SERVICE BULLETIN

M-1143

2004 SPORTSTER OIL TANK VENT HOSE ROUTING PRODUCT PROGRAM NO. PP9

Figure 1. Correct Oil Tank Vent Hose Routing

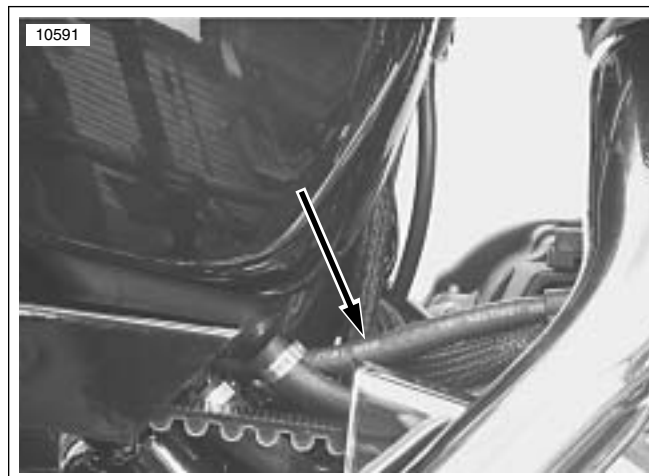
See Figure 1. If oil tank vent hose is routed correctly (i.e., just above return hose and even with bottom of oil tank), no further action is required.

Figure 2. Incorrect Oil Tank Vent Hose Routing

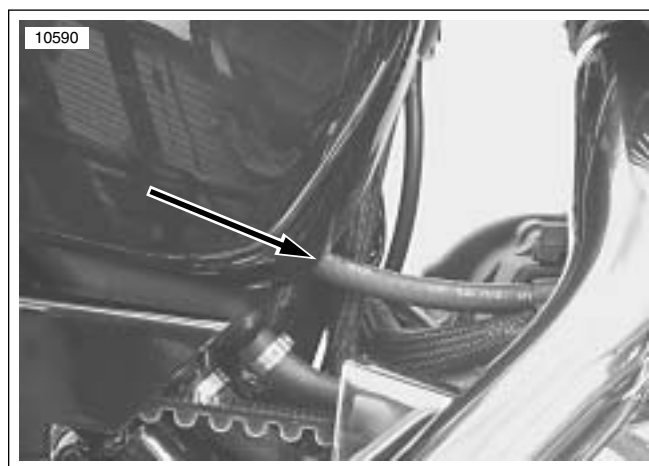
See Figure 2. If oil tank vent hose is routed high (i.e., up behind oil tank), it must be repositioned as follows:

**Figure 3. Oil Tank Vent Hose Pinch Point
(Oil Tank Removed for Clarity)**

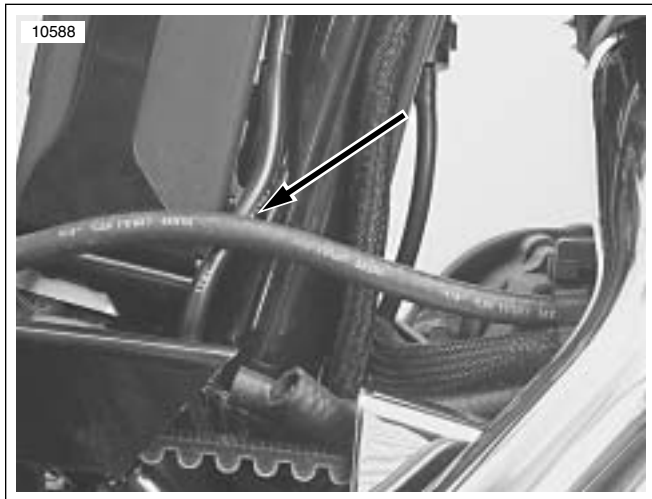
See Figure 3. This figure shows the area where the oil tank vent hose may be pinched between the oil tank and the negative battery cable and battery tray.
